Gowers Street, Rochdale

Design and Access
Statement - Addendum

Rev P01

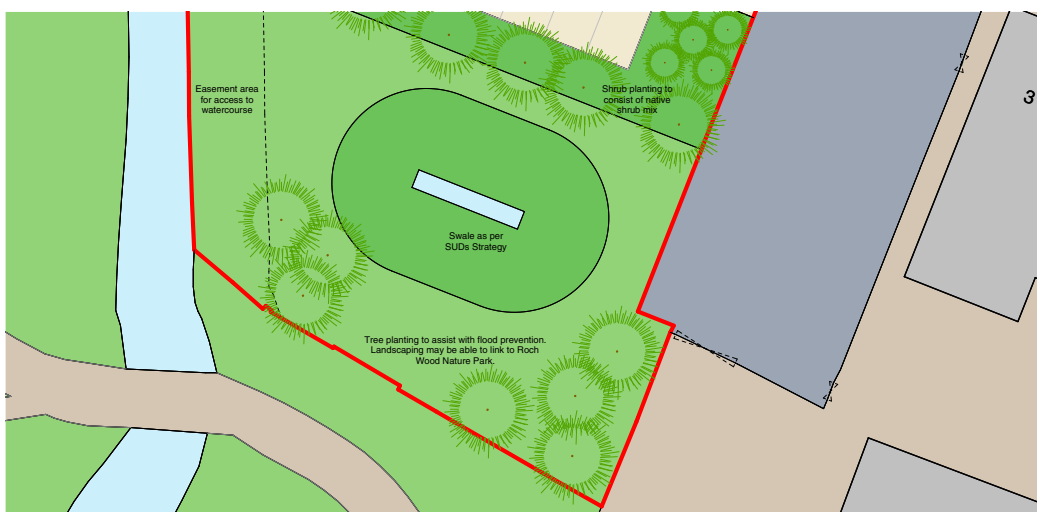
The Drainage Officer requested that the two points within the JBA Addendum to the Drainage Strategy be provided at Discharge of Drainage Conditions stage. These are the permeable surfacing to the car parking area and the surface water attenuation basin which have now both been included on the site plan.

Based on the comments received 31/07/2022, the two final comments related to a 4m buffer zone being created, and that mitigation measures (assumed to be those mentioned by the Drainage Officer above) be implemented; both of which have now been included clearly on the site plan.

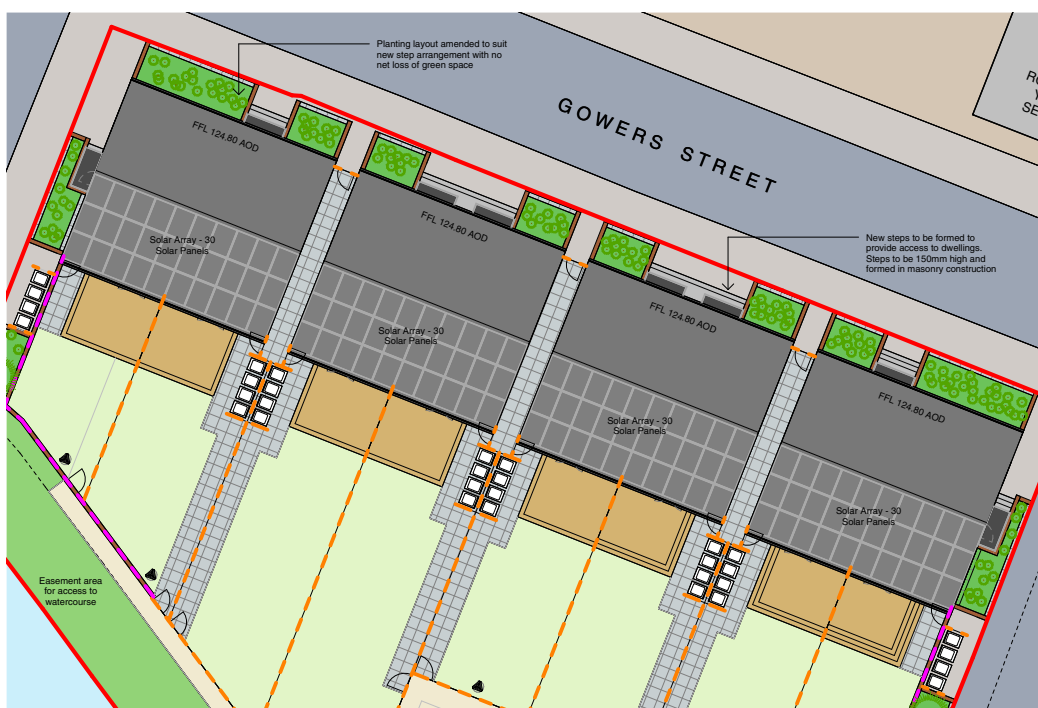
Based on the conclusions of the Flood Risk Assessment by JBA Consulting version P03 dated March 2021, it was determined that FFLs should be elevated above the '1% AEP + 70% increase in flow' level which is 124.34m AOD.

The revised FFLs for the houses are now set at 124.80m AOD which allows for a 460mm freeboard to the Flood Zone 2 level.

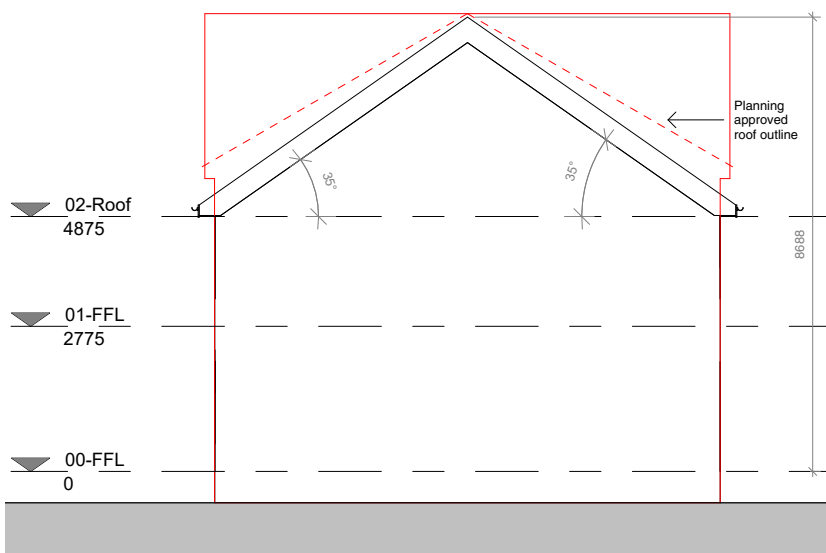
In order to maximise the roof area available for solar panels, the roofs have been amended to have a 35degree pitch to the south orientation and the two end plots changed to a gable end.
